**FINAL DRAINAGE REPORT FOR  
HOMESTEAD AT STERLING RANCH  
FILING NO. 2**

**Engineering Review**

**EPC Planning & Community  
Development Department**

Project #09-007  
SF -19-004

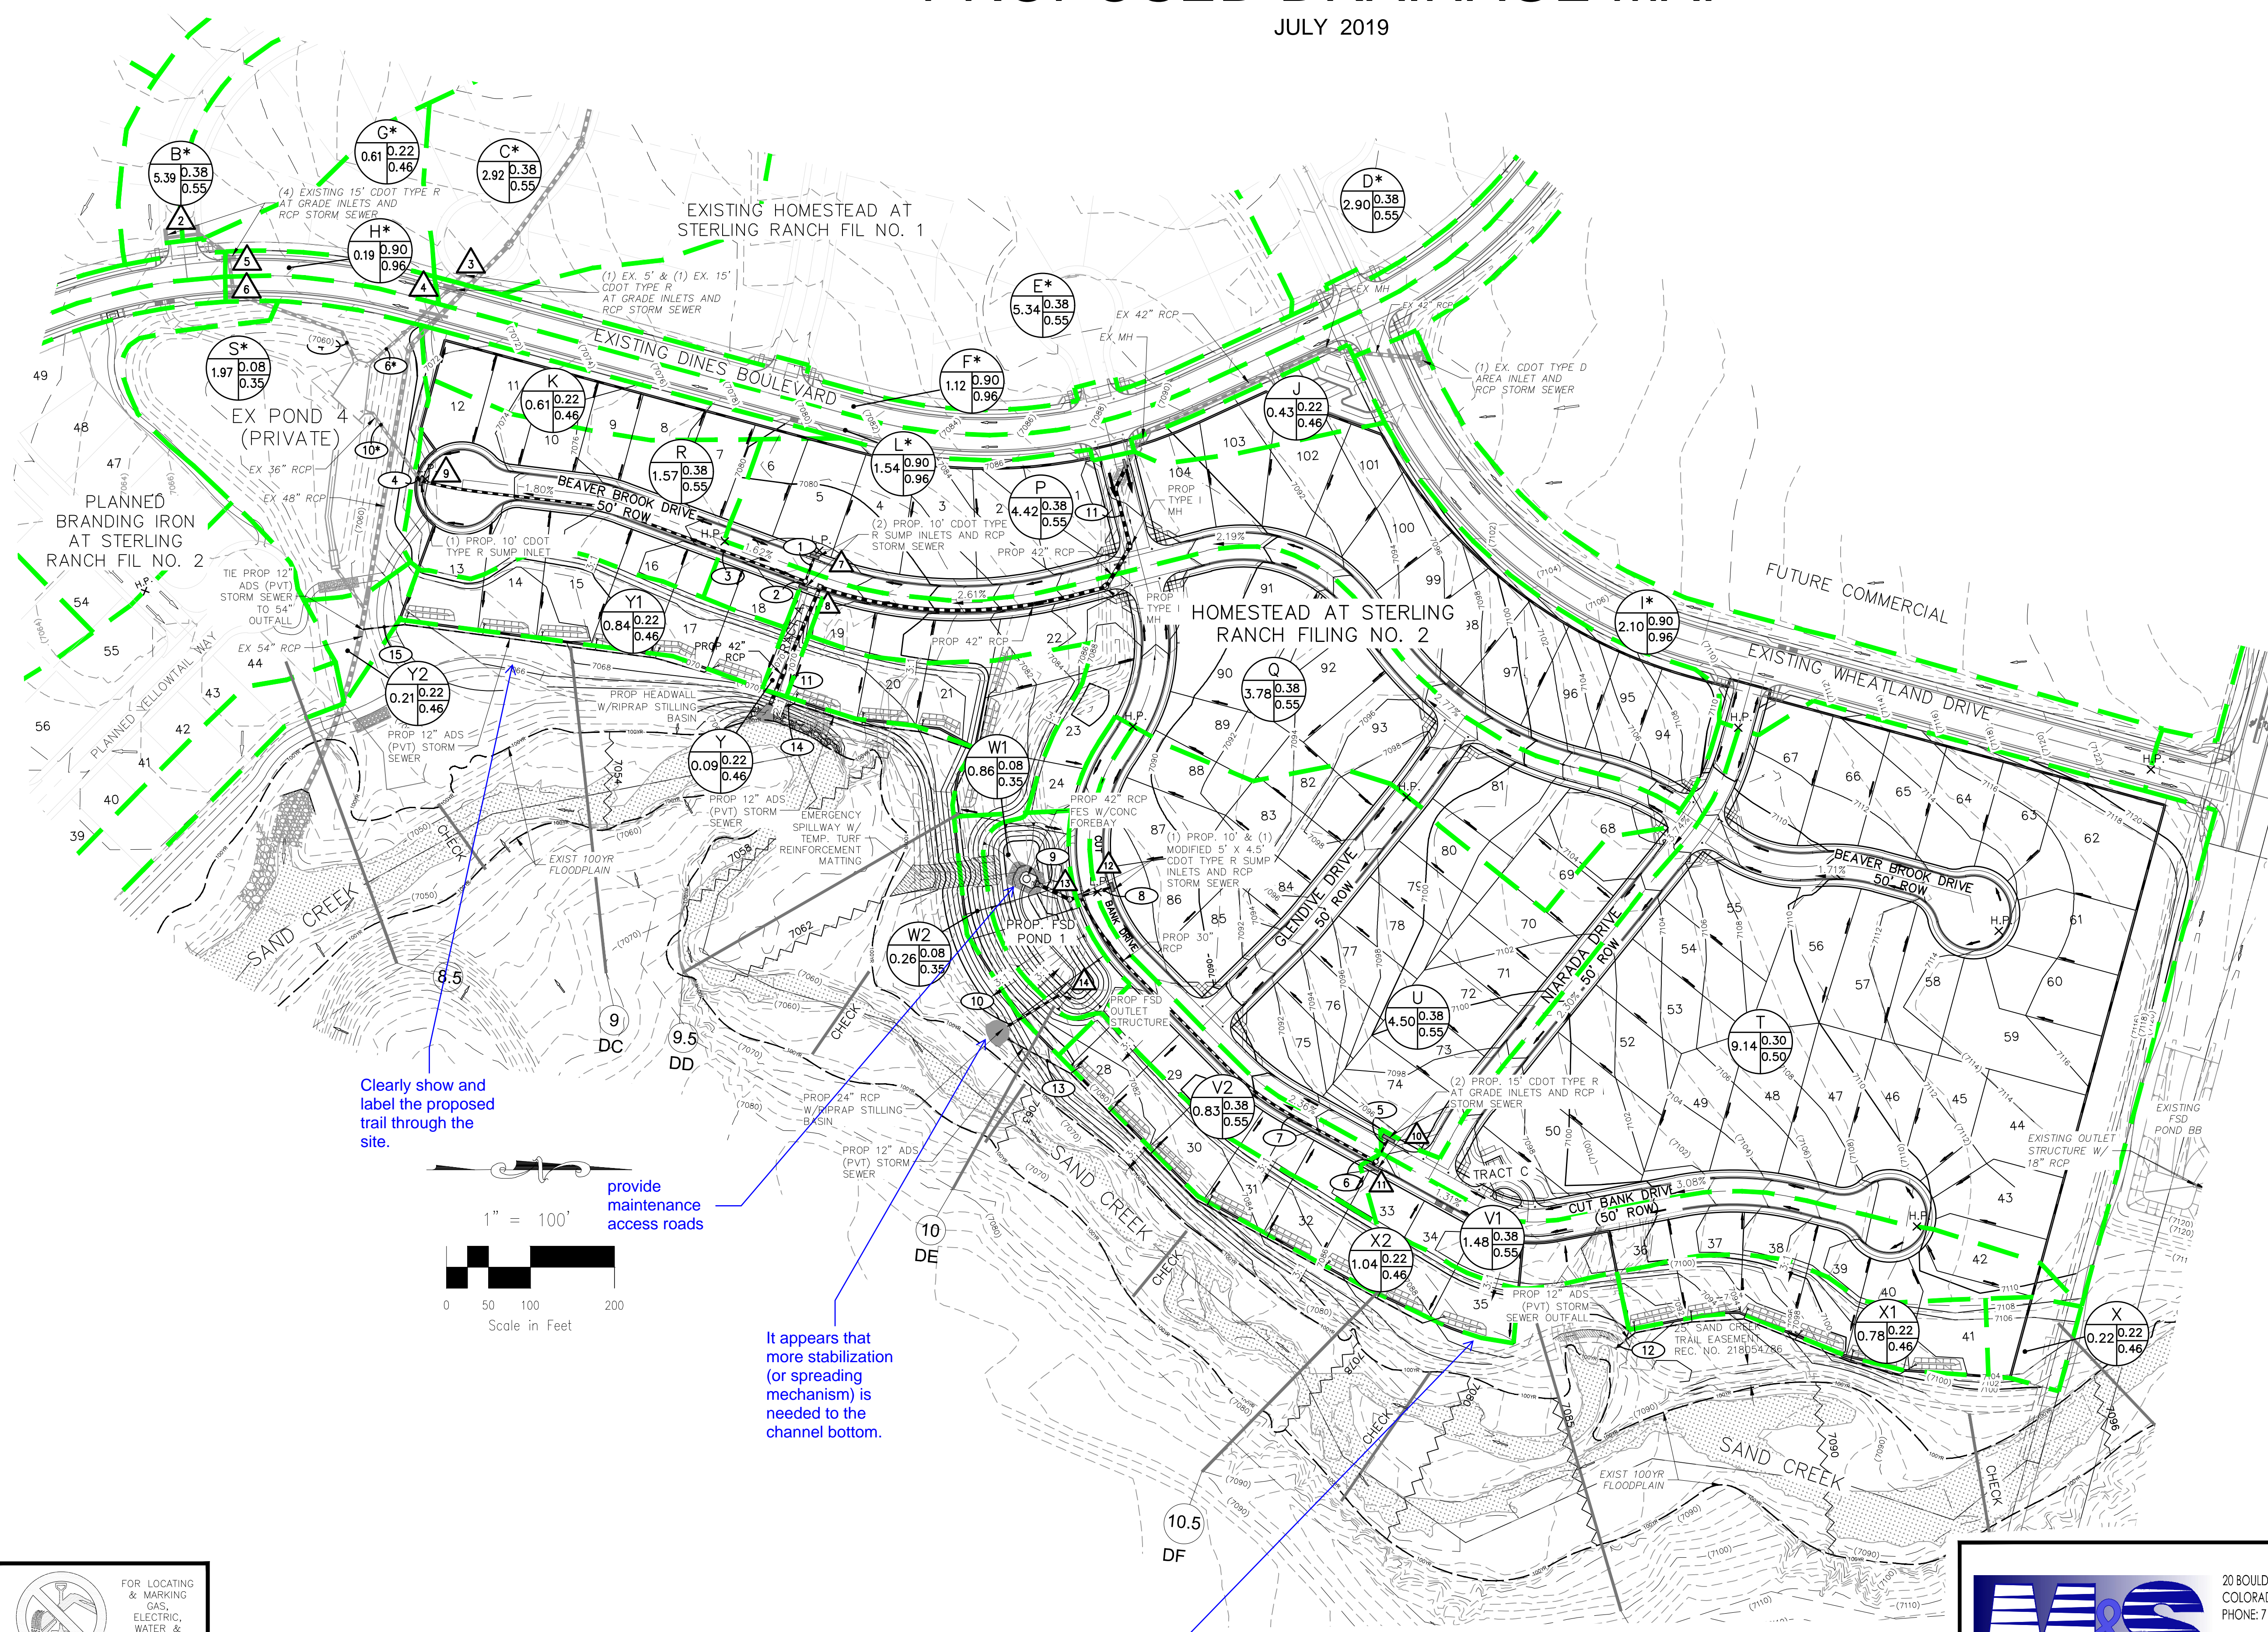
Provide existing conditions map

Provide EDB and SFB details

Clearly show and label the proposed trail through the site.

provide maintenance access roads

It appears that more stabilization (or spreading mechanism) is needed to the channel bottom.
